EROSION AND SEDIMENT CONTROL PLAN

PROJECT NUMBER: 218113

ESCP COVER SHEET

**ESCP
EXISTING
CONDITIONS**

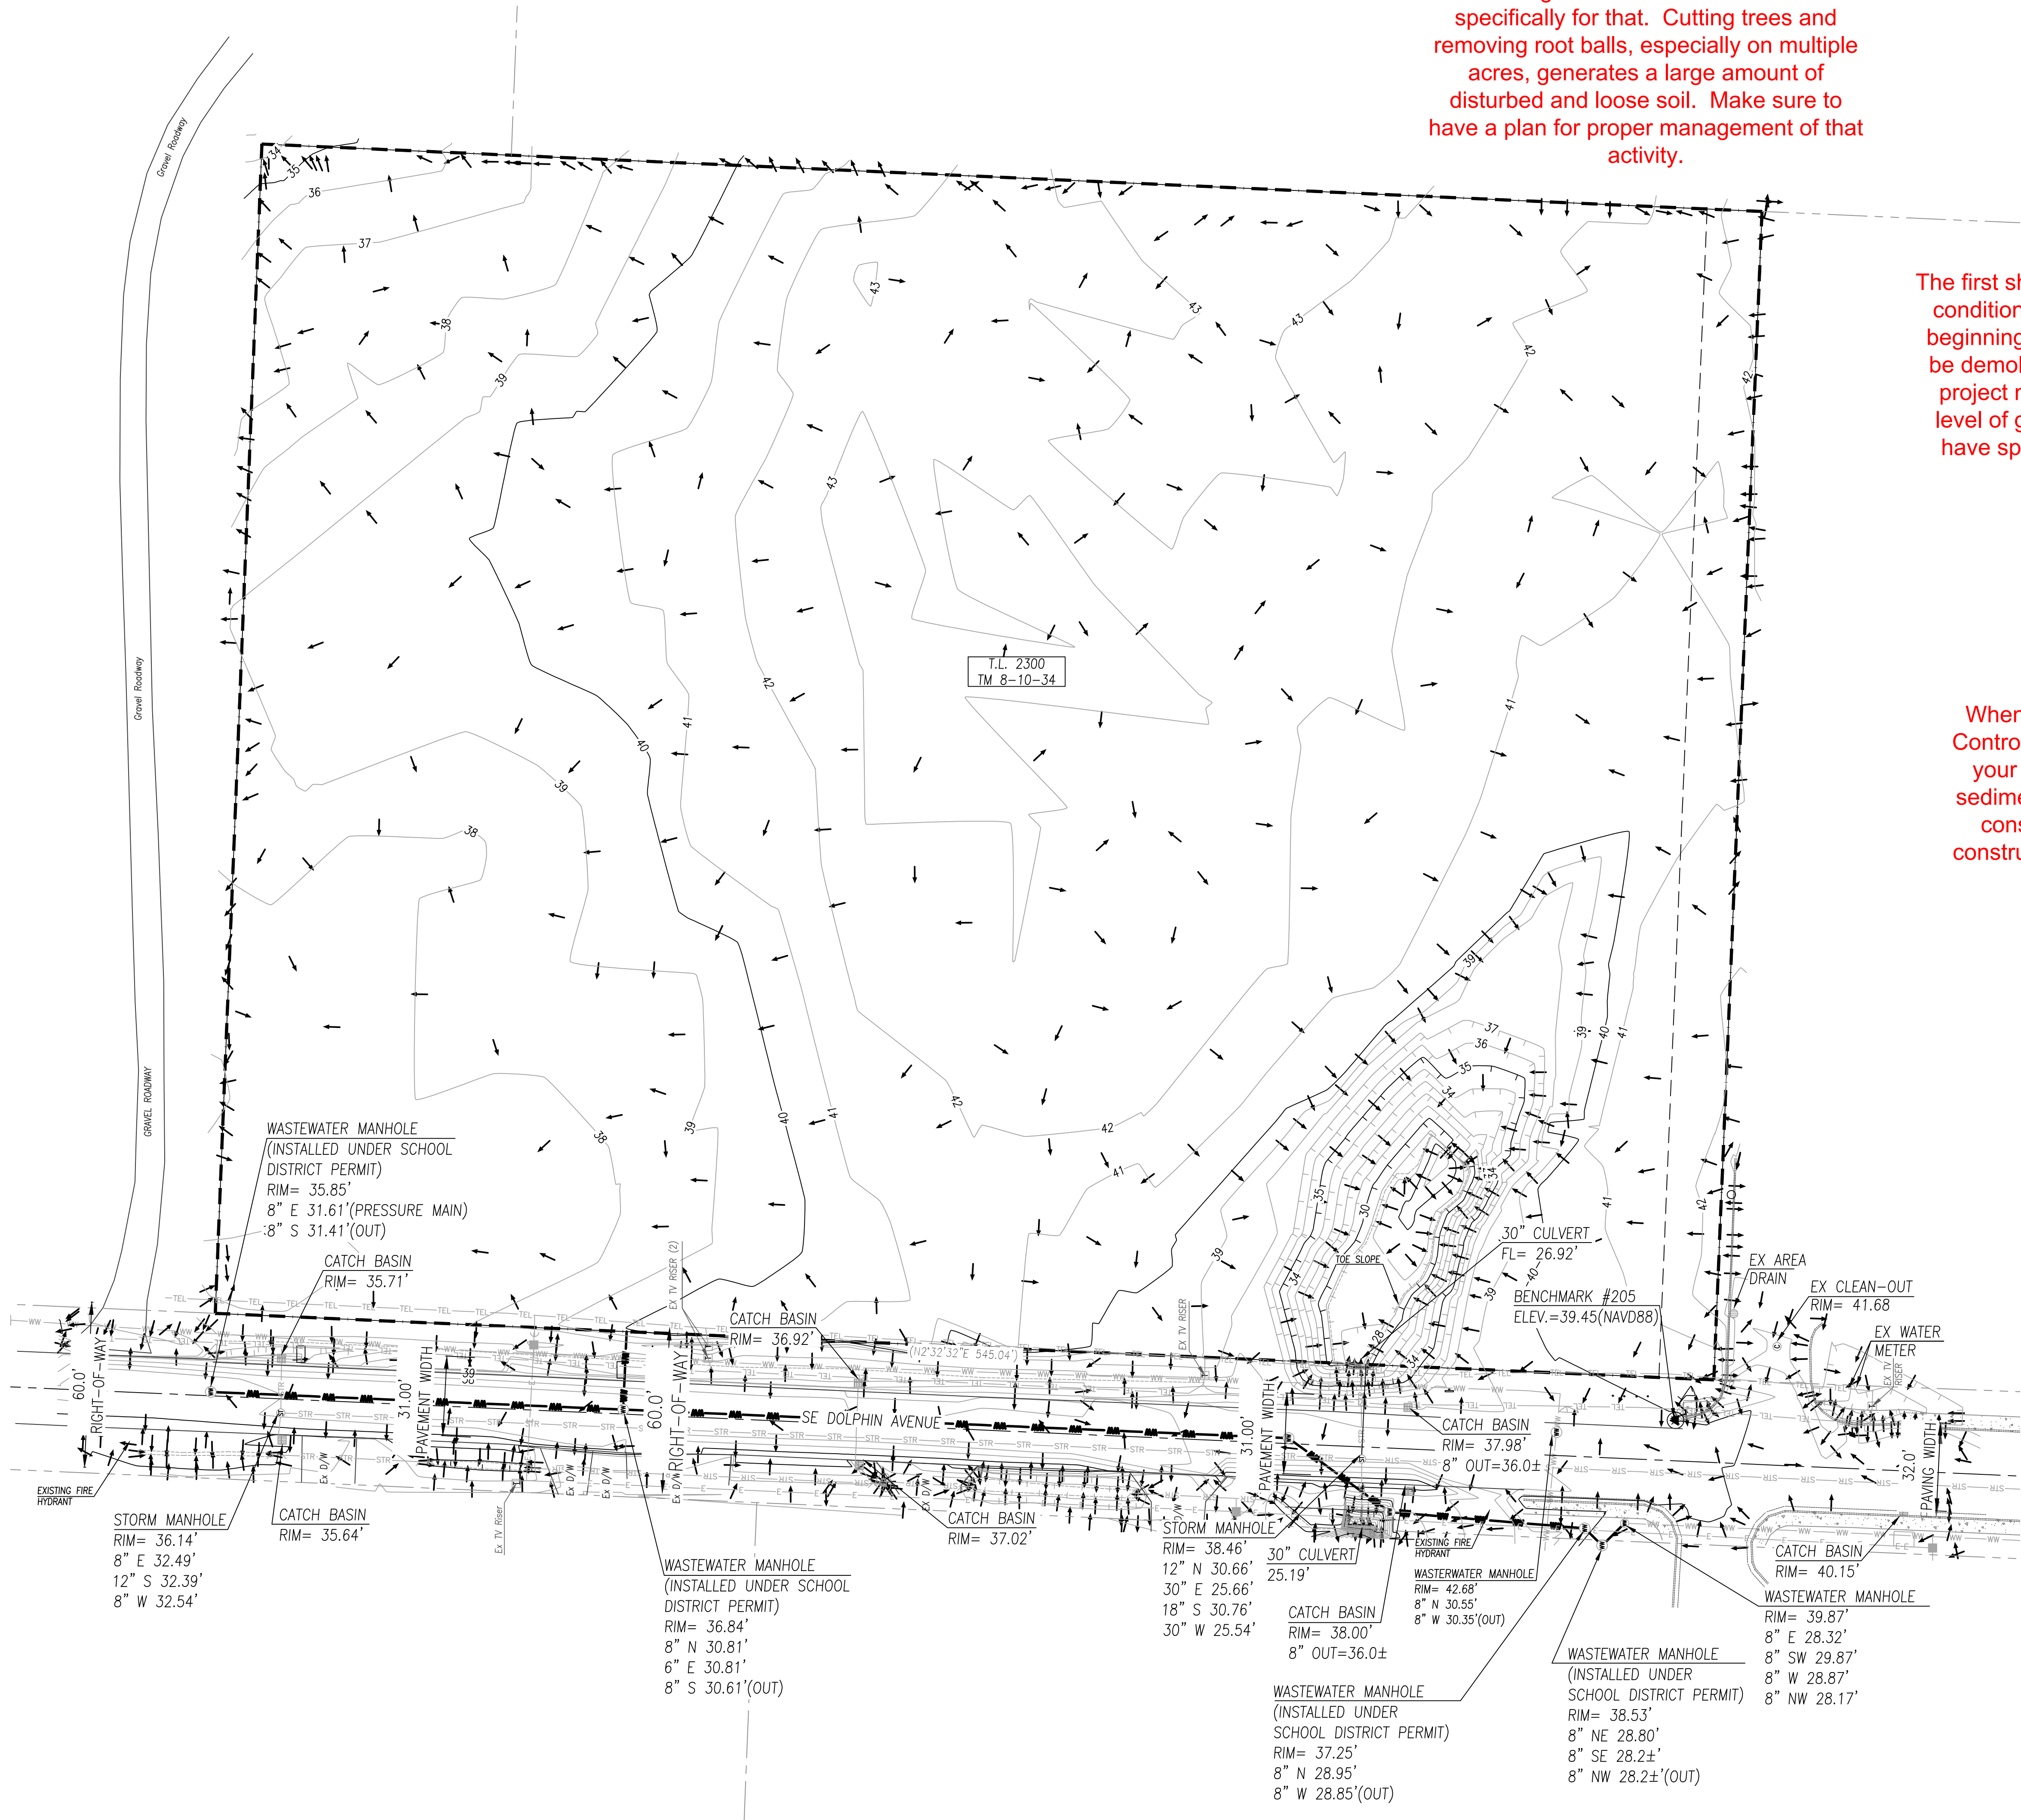
Removing a lot of trees? Draft a sheet specifically for that. Cutting trees and removing root balls, especially on multiple acres, generates a large amount of disturbed and loose soil. Make sure to have a plan for proper management of that activity.

The first sheet should communicate the existing conditions - how is stormwater flowing at the beginning of the project? What structures will be demolished? The beginning stages of the project may not involve grading, but have a level of ground disturbance and staging that have specific erosion and sediment control needs.

SHEET: **EC-3.0**

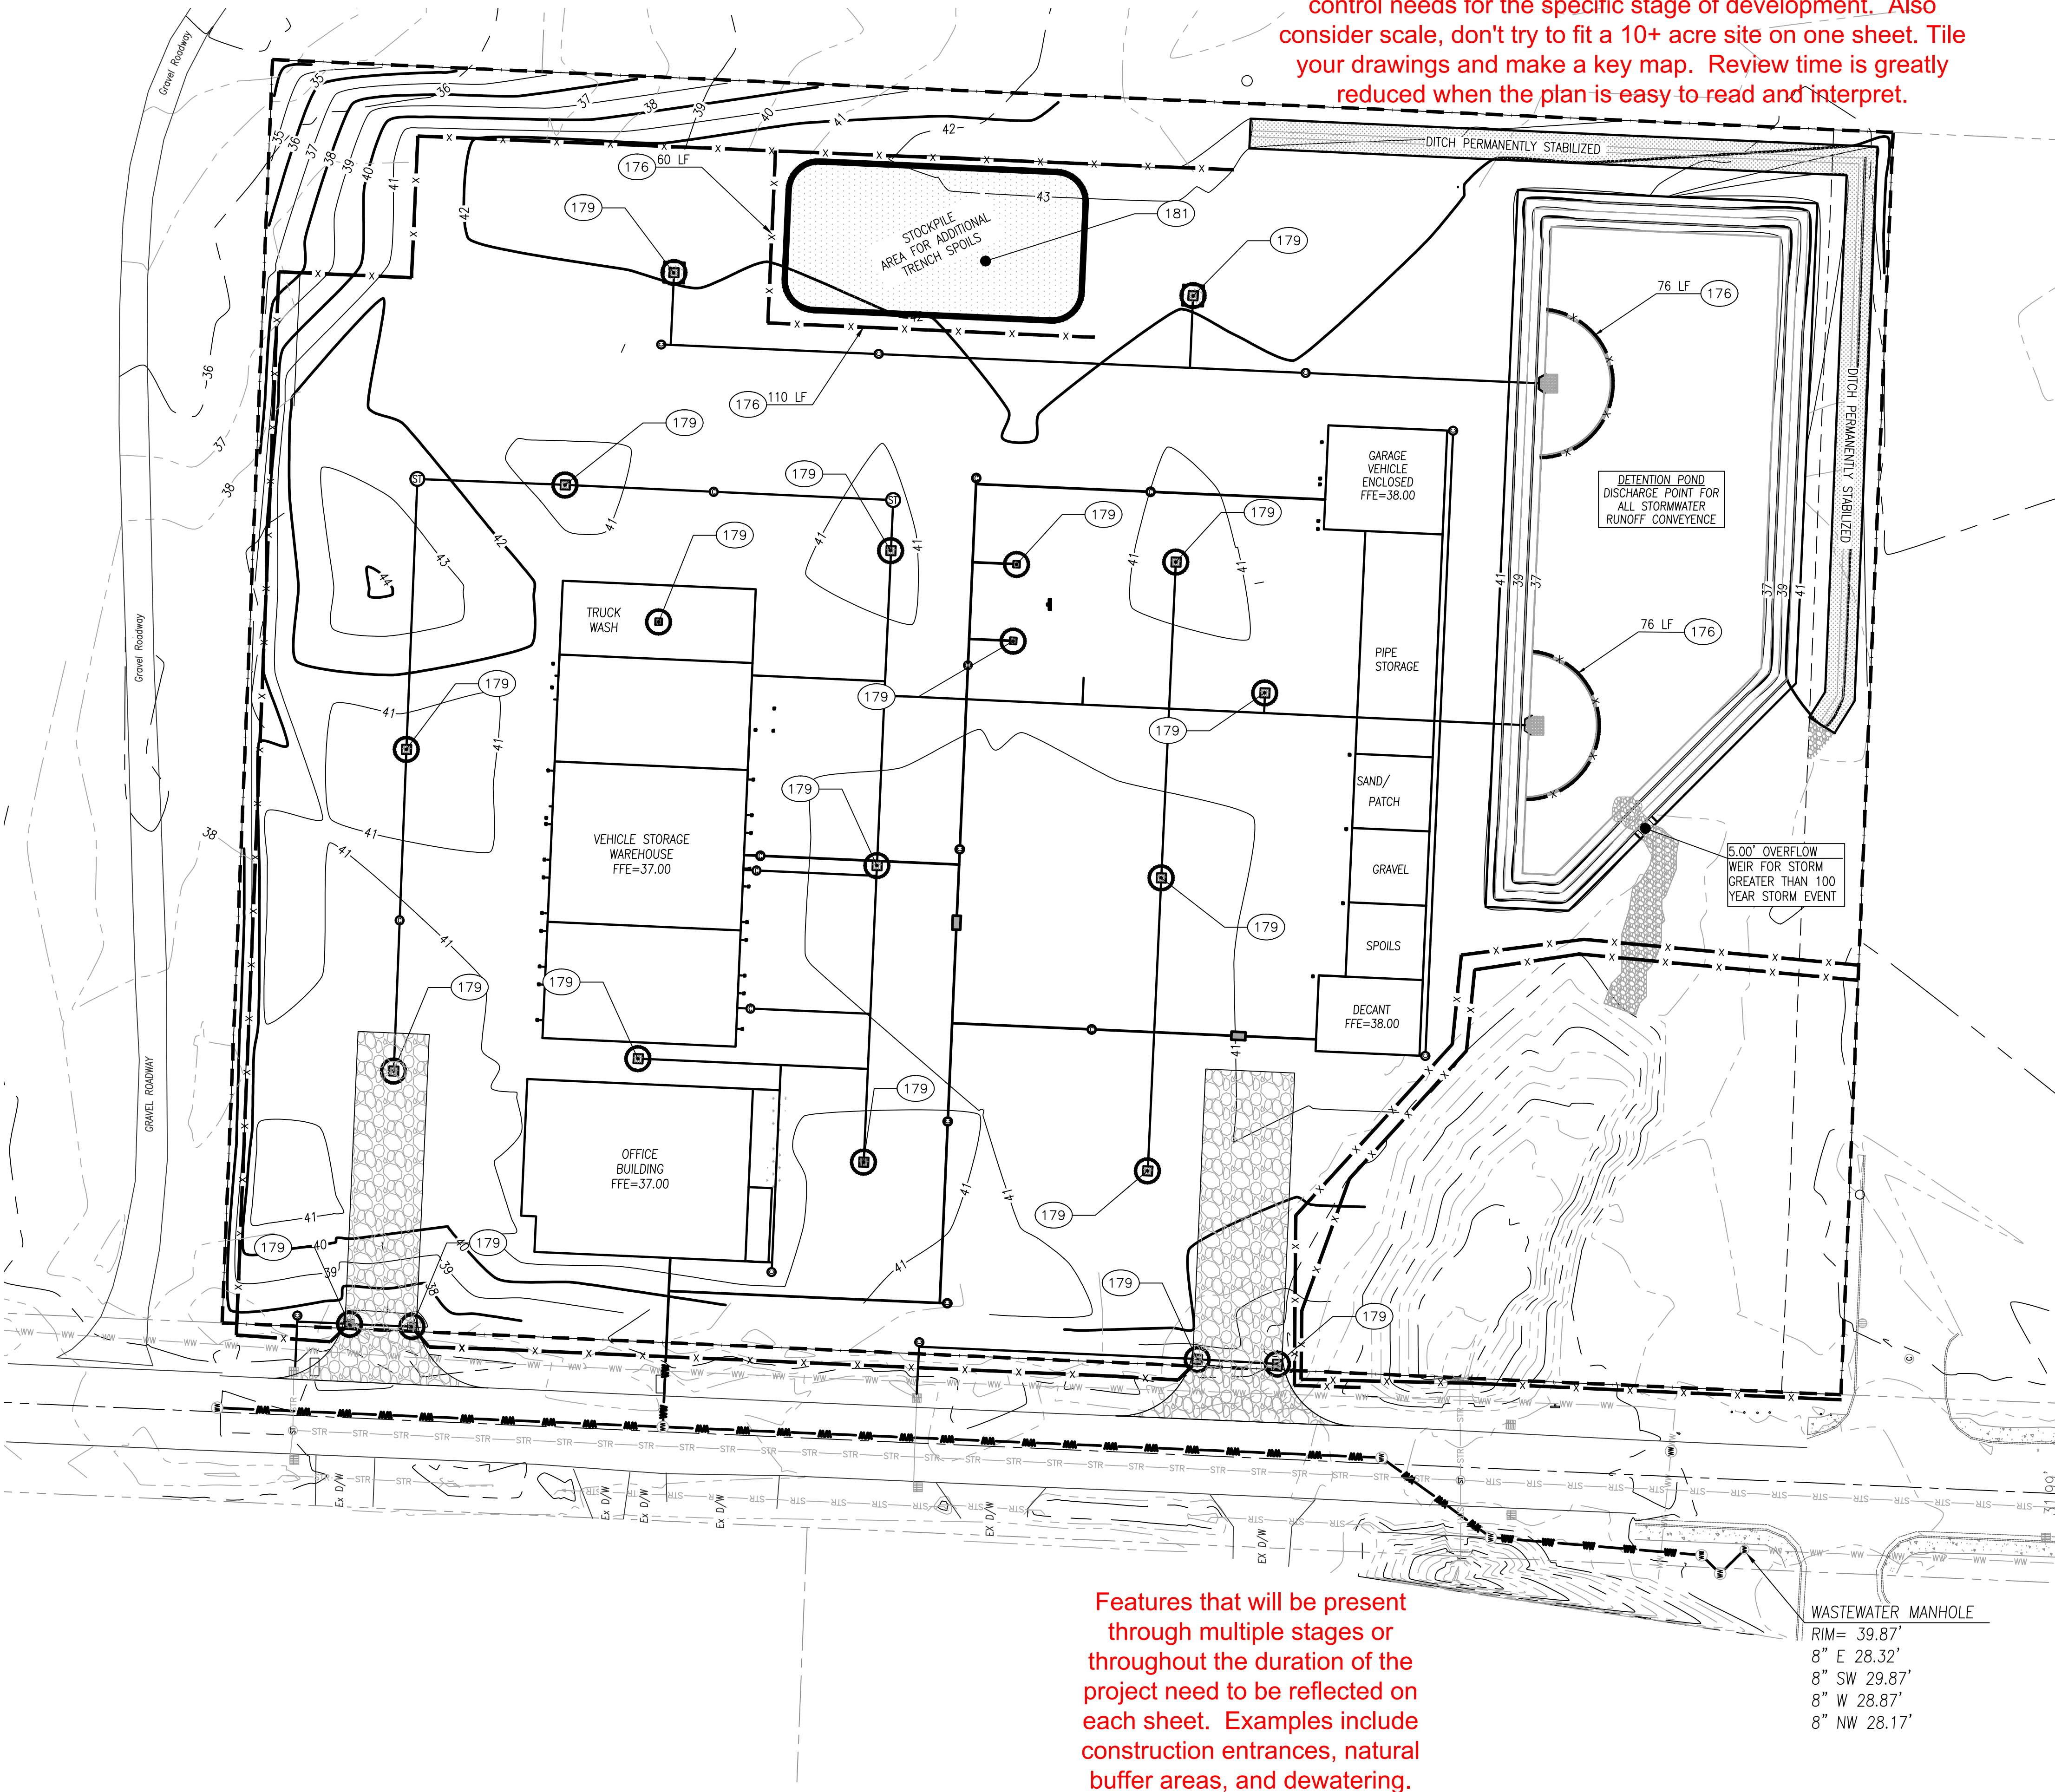
Add Seed Mix Information Here (i.e. composition percentages, supplier, total amount).

ADD STOCKPILE AREA AND STAGING AREA THAT INCLUDES SANITARY FACILITY AND WASTE RECEPTACLE WITH LID.

INCLUDE POND (BASIN) VOLUME TO MEET 2.2.17 SIZING REQUIREMENT. ADD RESTORATION PLAN IF UTILIZED DURING CONSTRUCTION ACTIVITIES.

A legend is always necessary. Any symbol you use needs to be defined here. You can use numbered or lettered keynotes for descriptions as well.

SHEET: **EC-4.0**
100% DESIGN DEVELOPMENT
SEPTEMBER 28TH, 2020

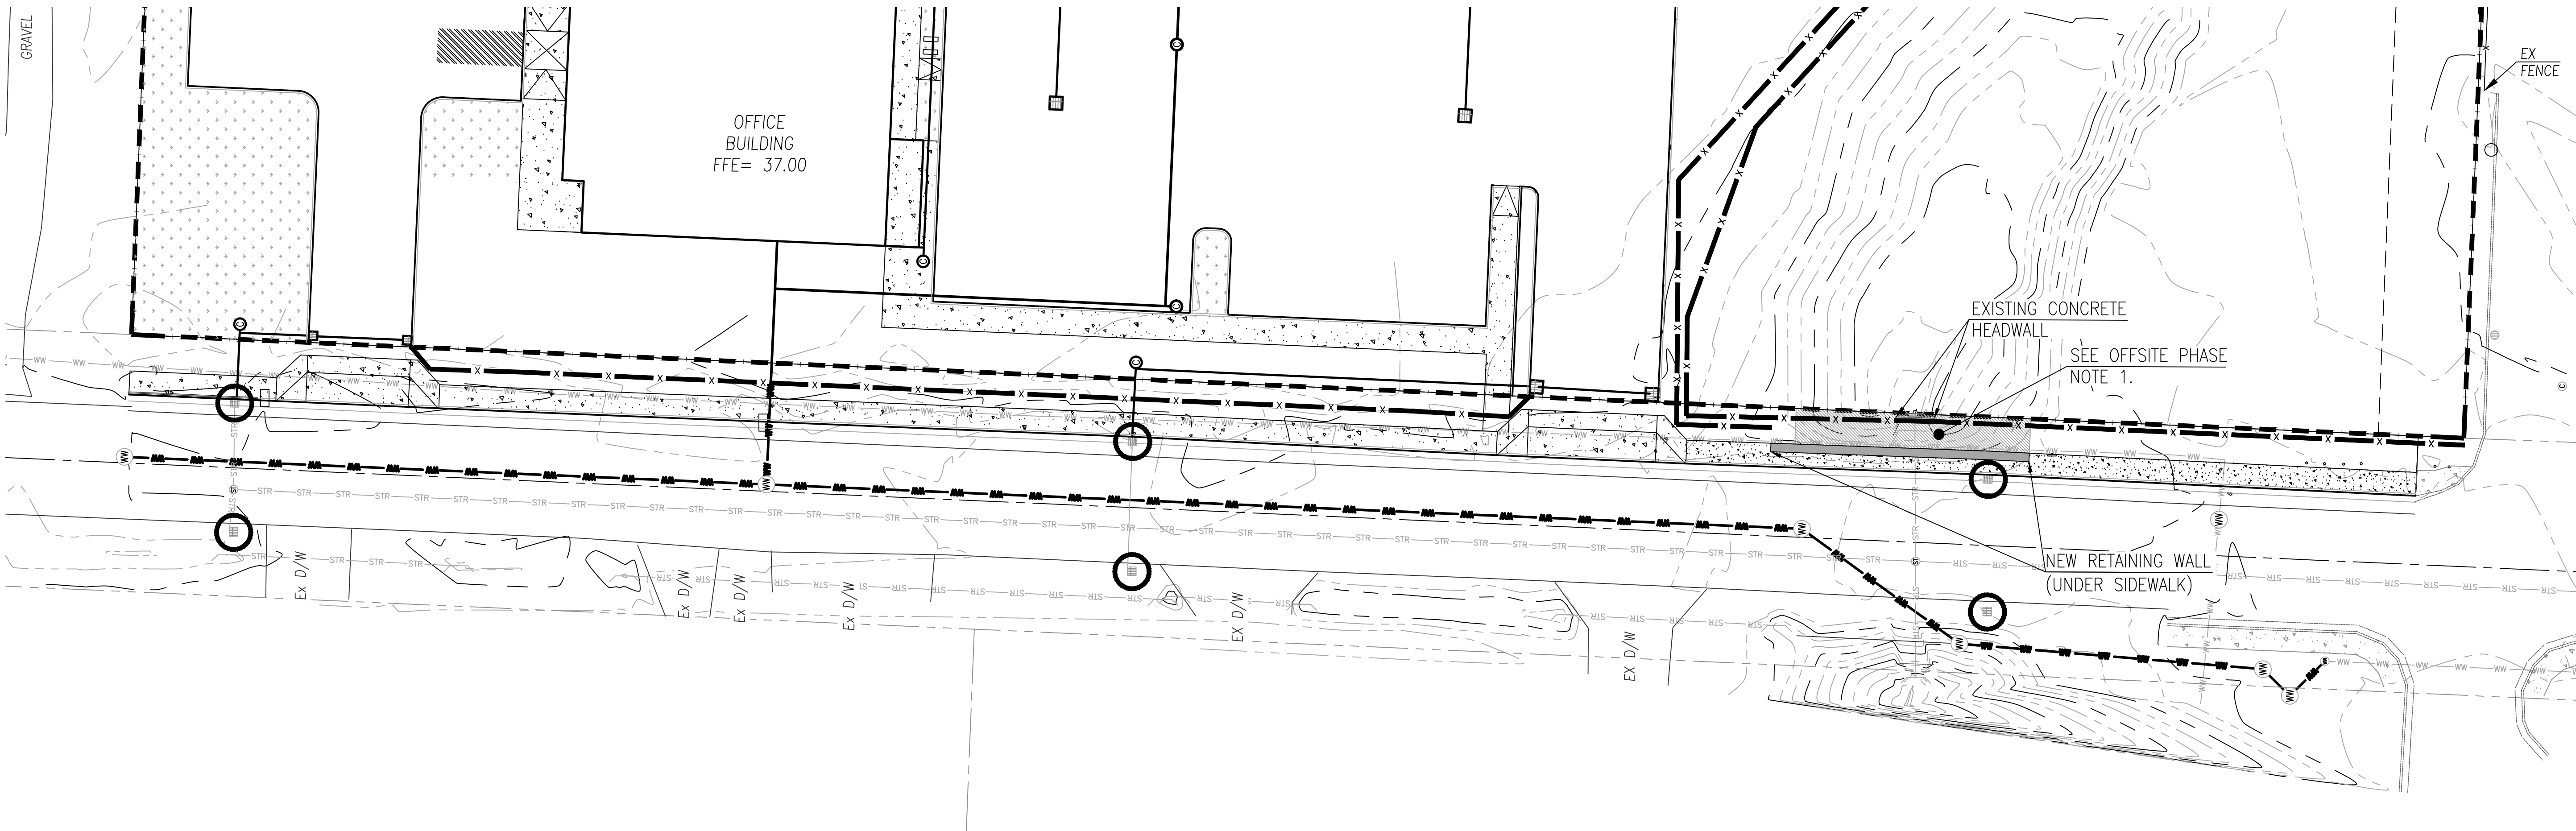
ADD STAGING AREA THAT INCLUDES SANITARY FACILITY AND WASTE RECEPTACLE WITH LID.

If possible, determine the background turbidity of the receiving waterbody. Make sure that the discharges from your site are no more than 10% higher than that number.

All dewatering must be addressed and managed appropriately, even authorized (non-polluted) dewatering.
